CITY OF TULSA
PUBLIC WORKS
Engineering

ADDENDUM NO. 4

ADDENDUM NO. 4
TO
PROJECT NO. 2036W0001Z, 2036A0024Z & TMUA-W 22-37
ARTERIAL STREET RECONSTRUCTION GILCREASE MUSEUM RD. (N. 25th W. AVE.) W. ADMIRAL BLVD. TO W. PINE ST.

ADDENDUM NO. 4
TO
GILCREASE MUSEUM RD.
(N. 25TH W. AVE.)
W. ADMIRAL BLVD TO W. PINE ST.
PROJECT NOS. 2036W001Z, 2036 A0024Z & TMUA-W 22-37

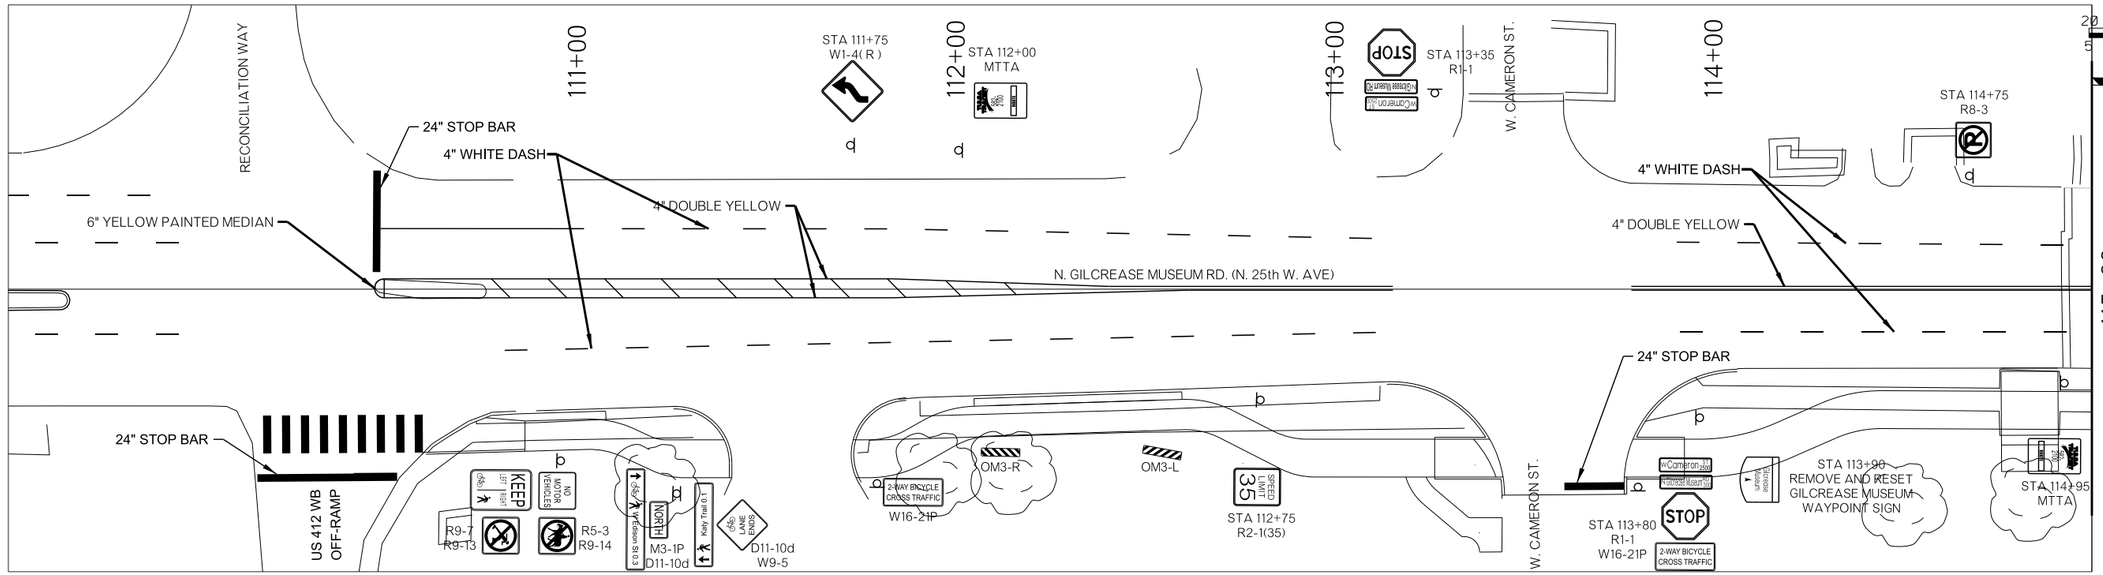
- No. 59 with added note for existing storm drain to remain in place for Sliplining at Sta 172+80, 50'RT.
- No. 62 with diversion swale/berm cleared forest area shifted 50' north; total area of clearing is unchanged.

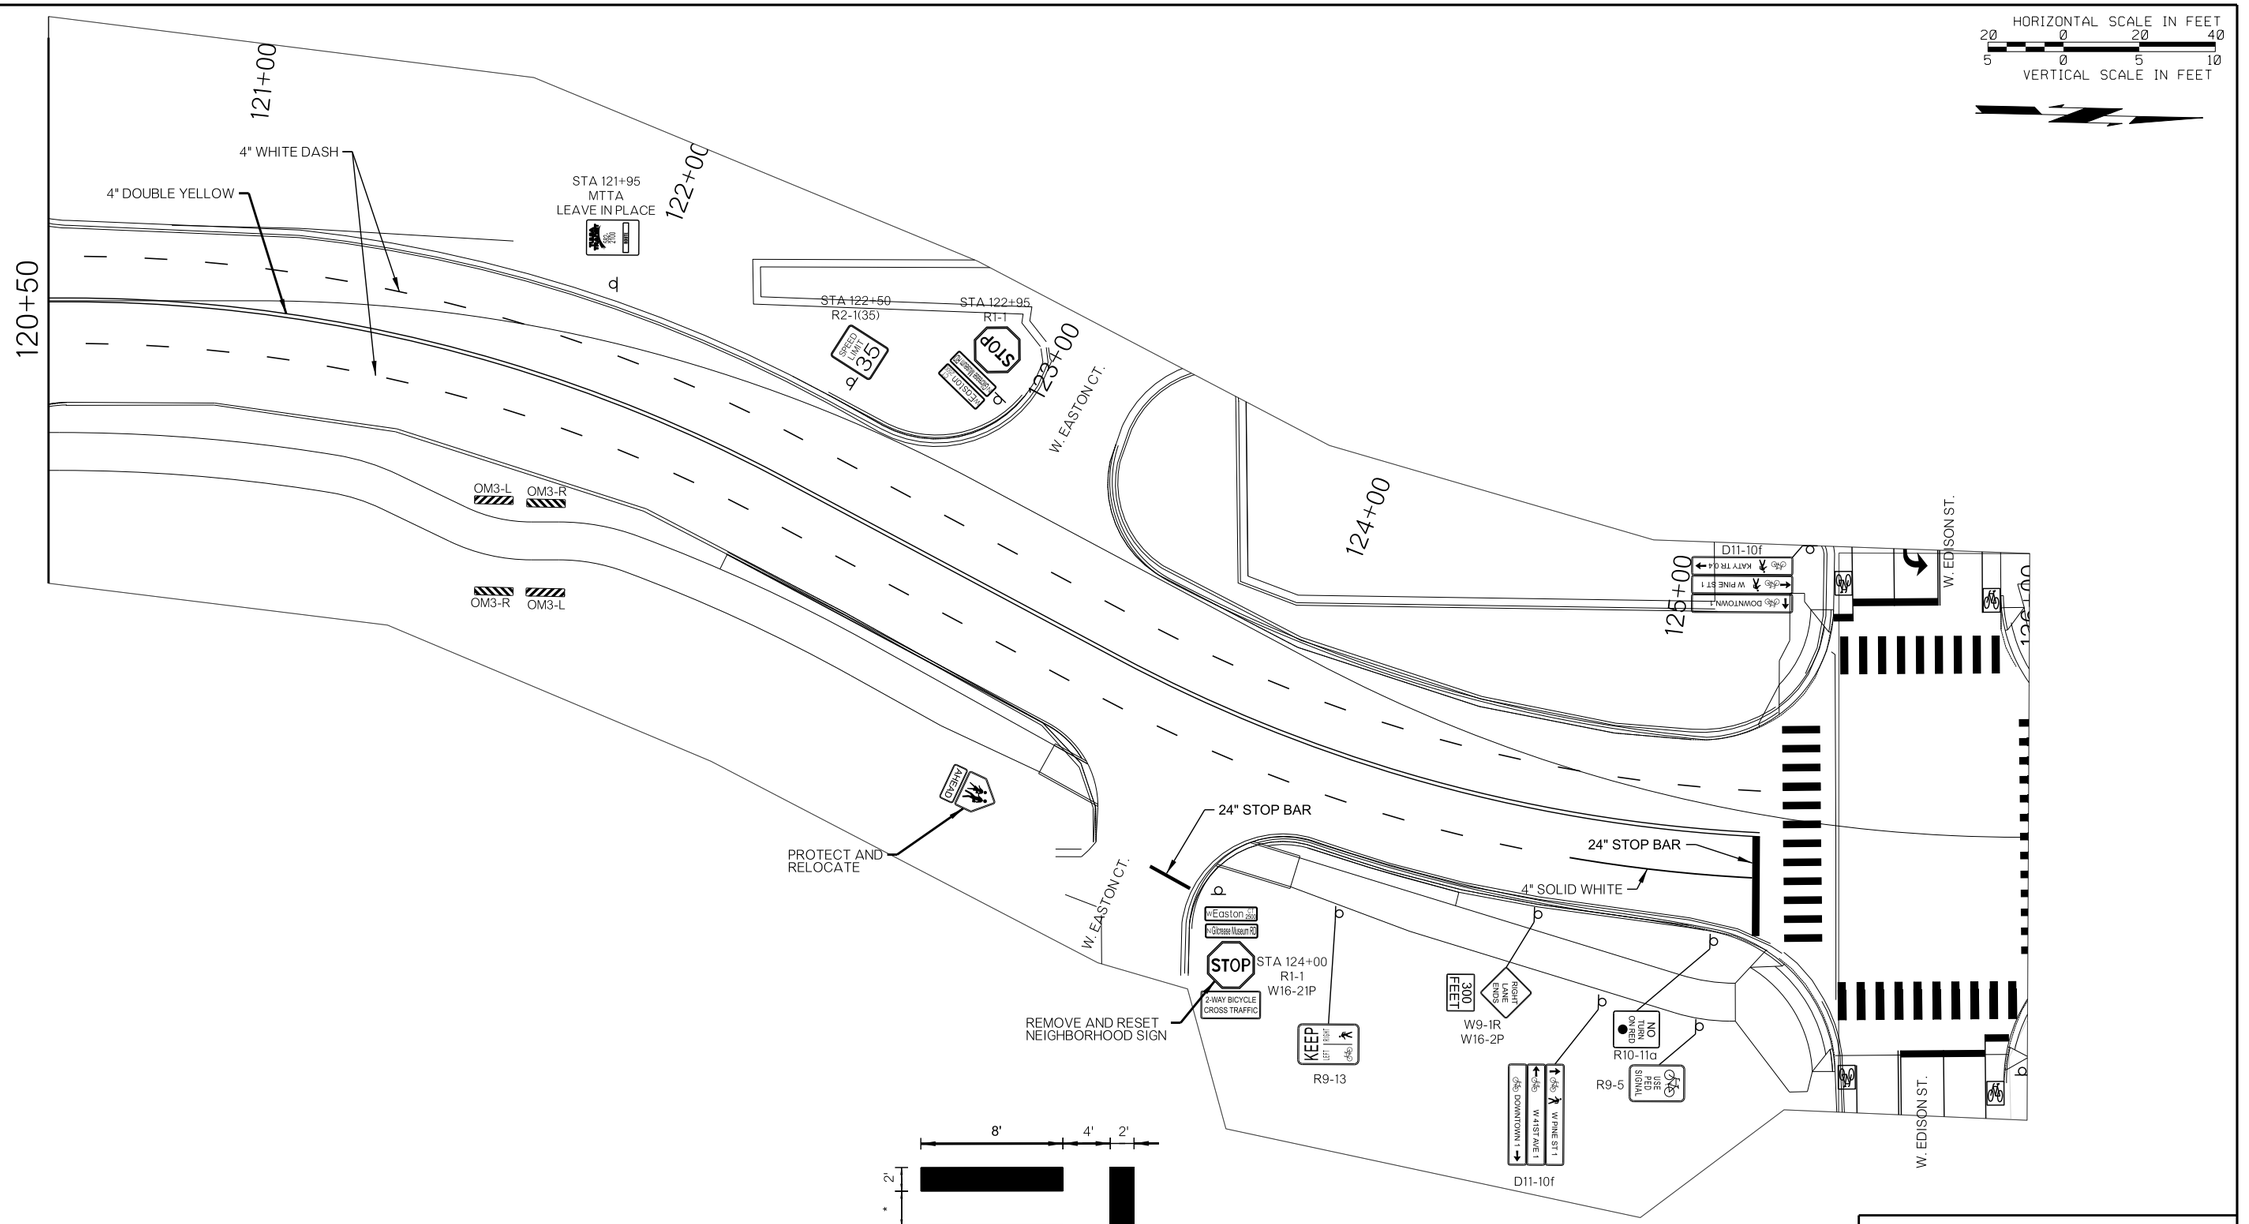
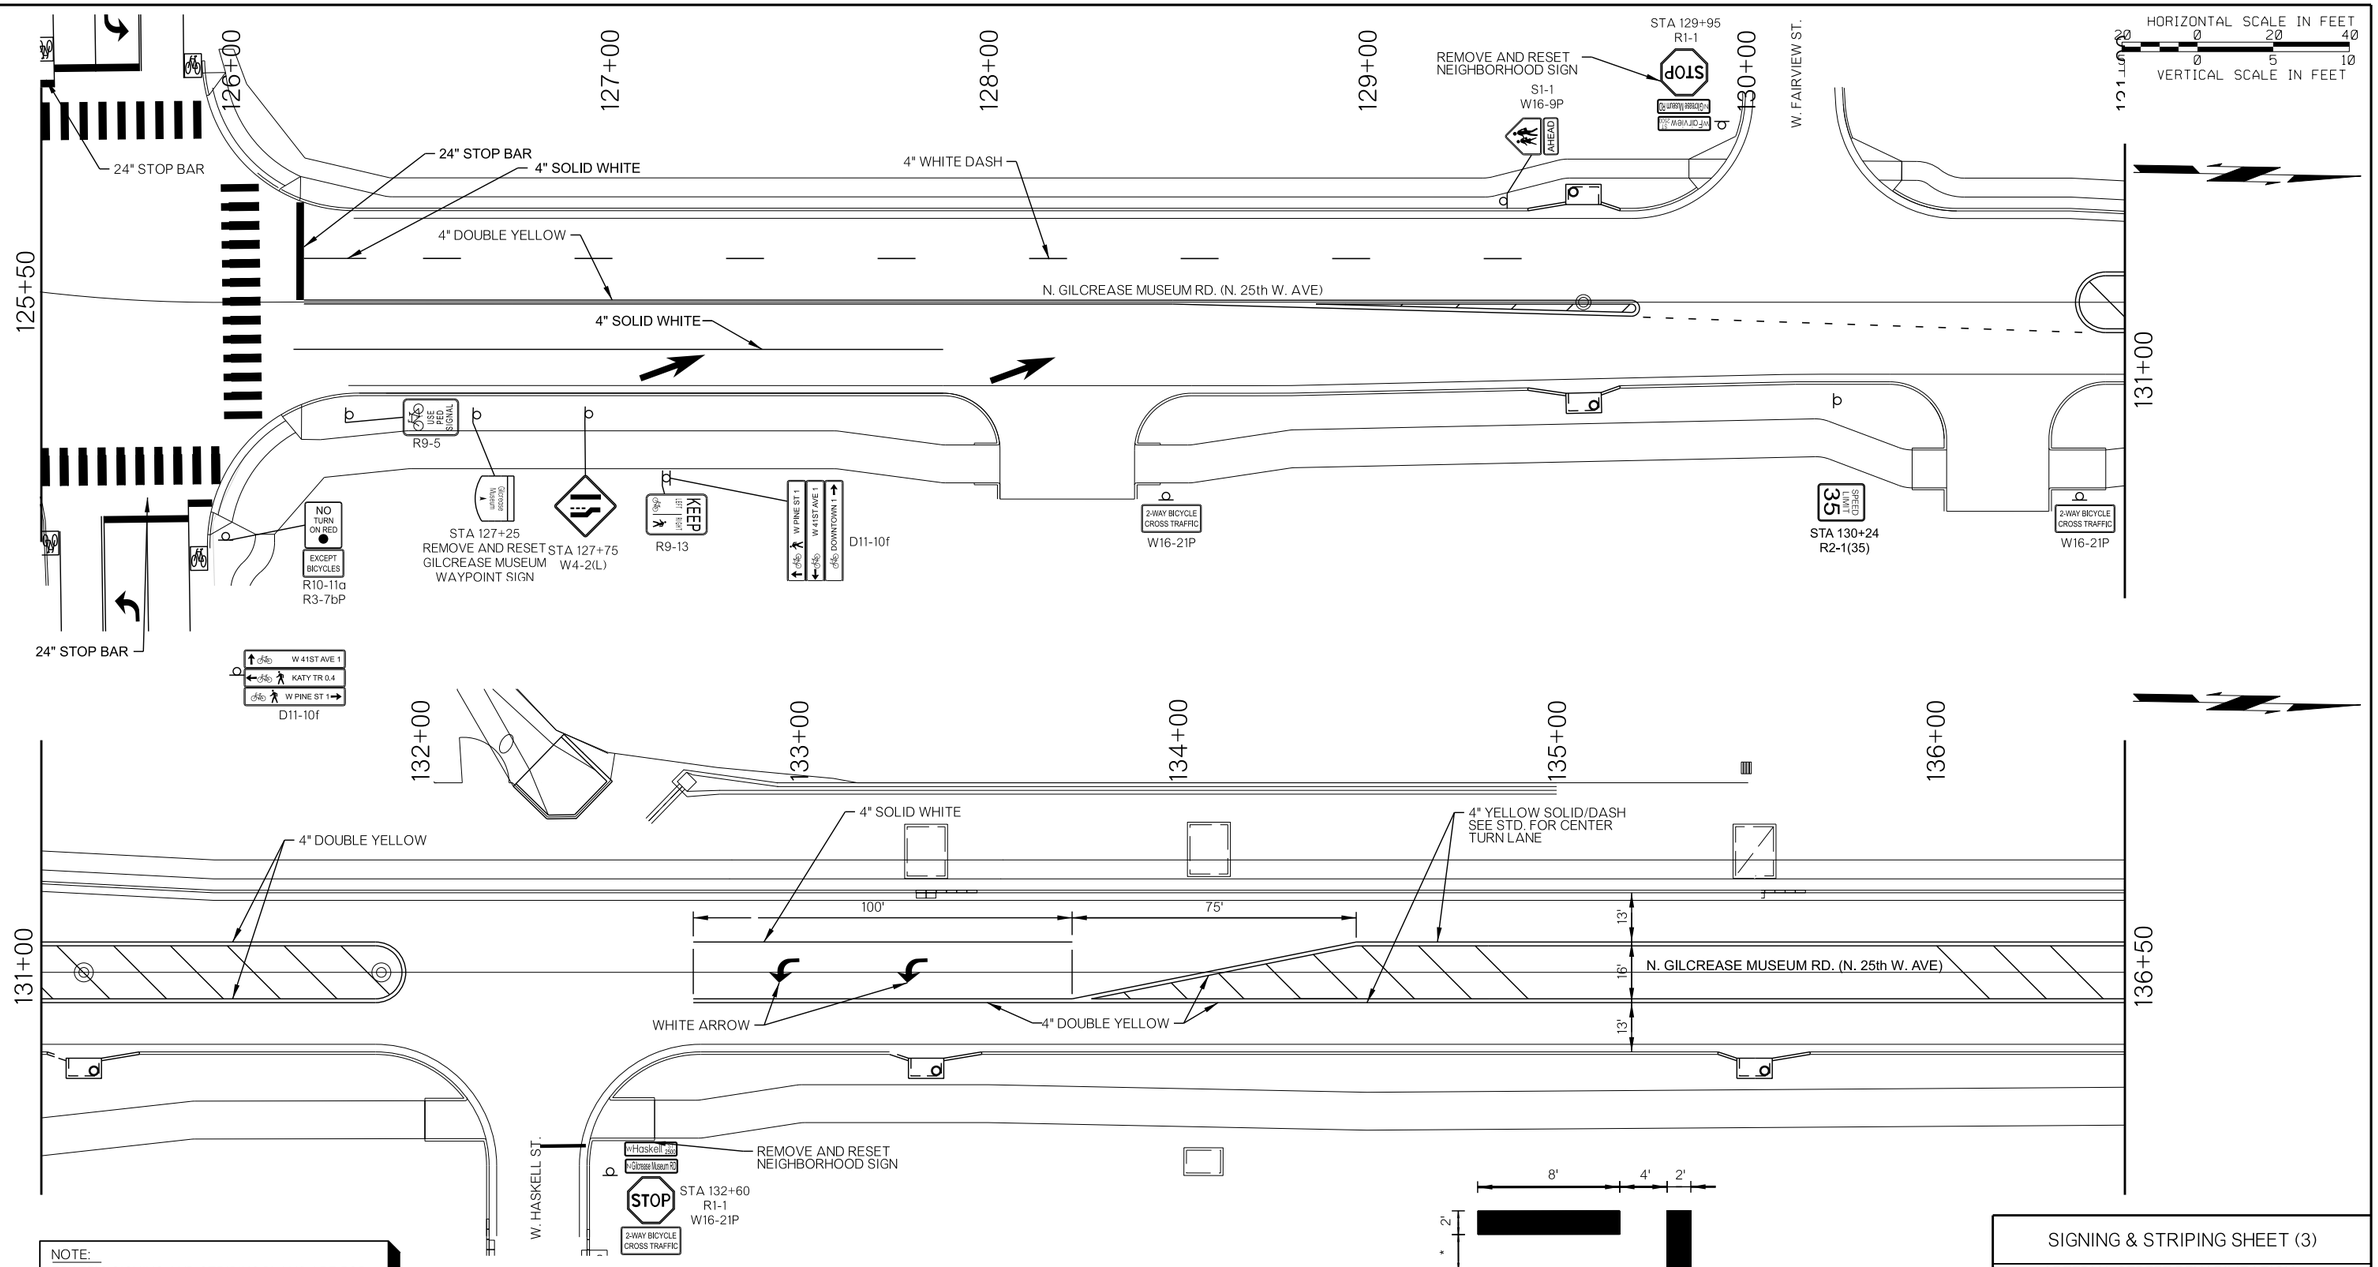
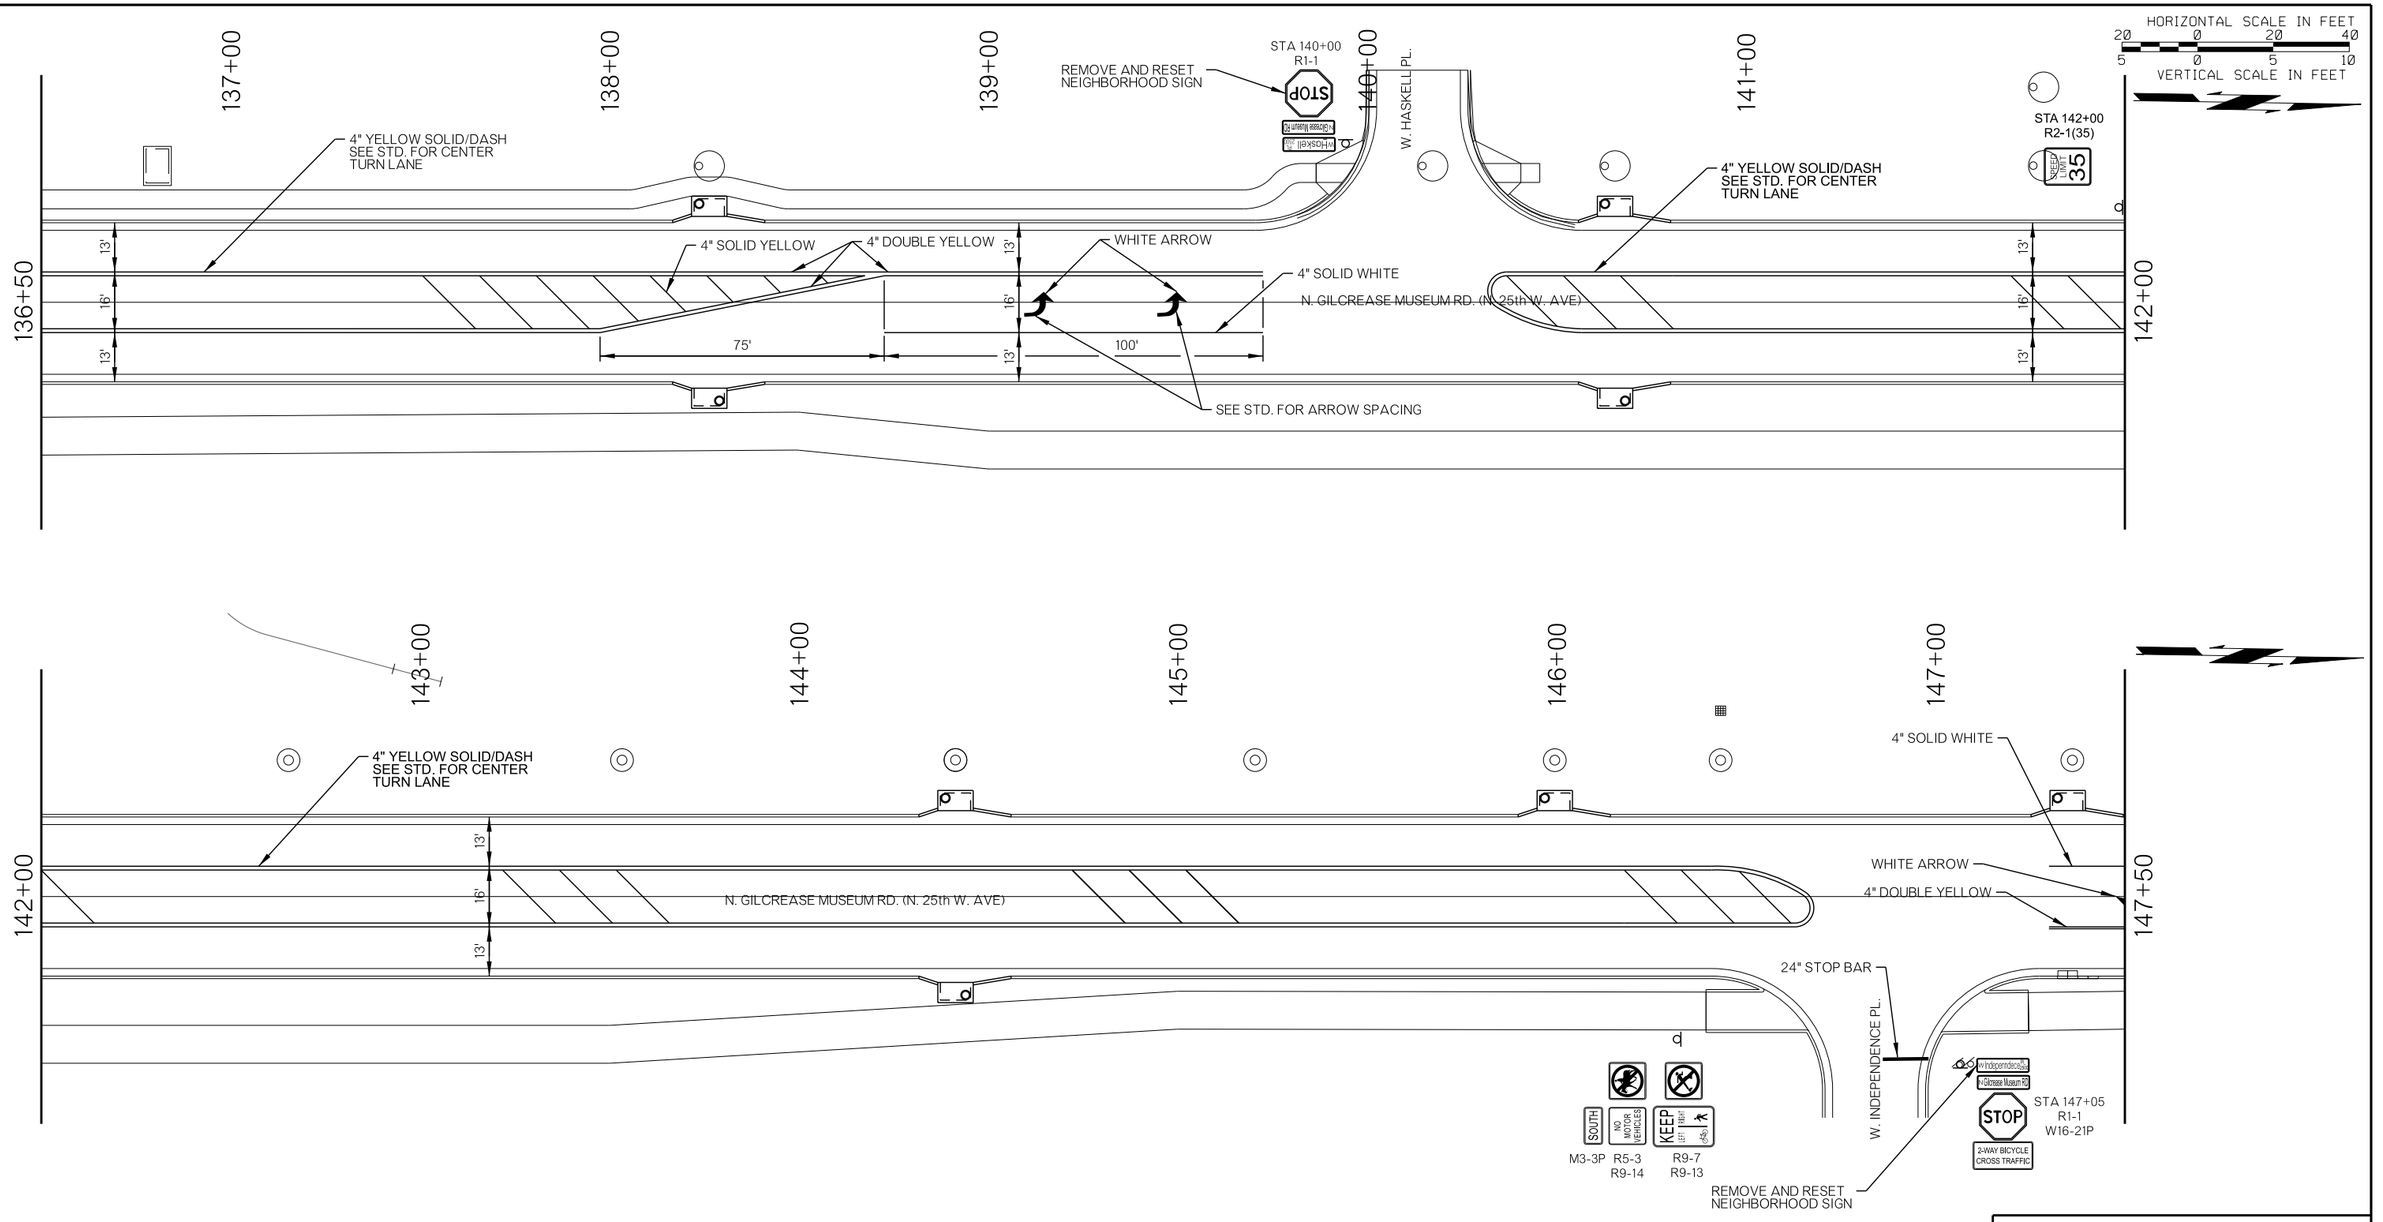
- Nos. 63 to 70 with revised Signing and Striping. Some Trail Signage removed.
- Nos. 71 to 73 with revised Joint Layouts to match striping.
- No. S1 with revised Quantities and Notes.
